# Conceptual Review Agenda

Schedule for 10/06/14 to 10/06/14

# 351 Linden St. Multi-family

# **Conceptual Review**

Project	SITE PLAN	Sheet	SITE
Date	August 26, 2014		
State	On Drawing

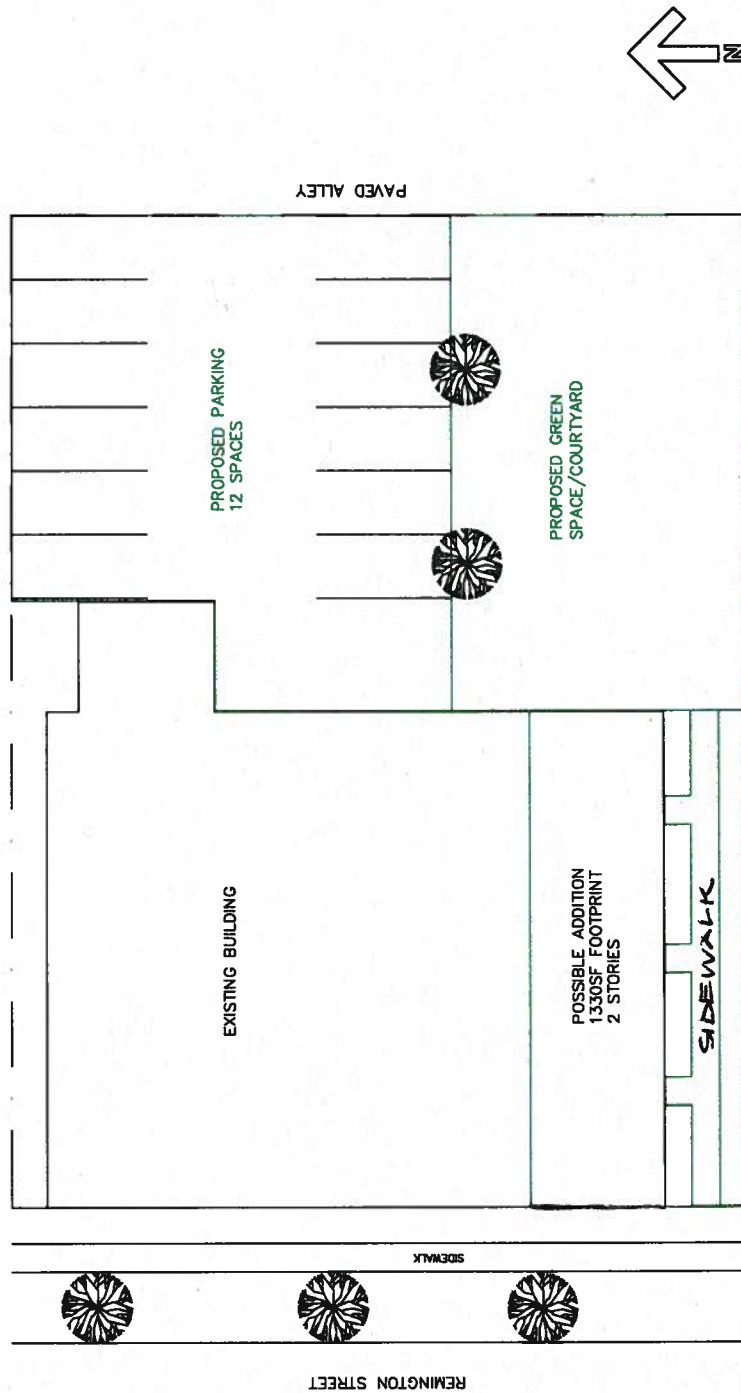
8. LCUASS parking setbacks (Figure 19-6) apply and will need to be followed depending on parking design.
9. The existing driveway off of Remington will need to be removed or narrowed so that it only serves the property to the south once the carport is removed and vehicular access no longer occurs off of Remington.
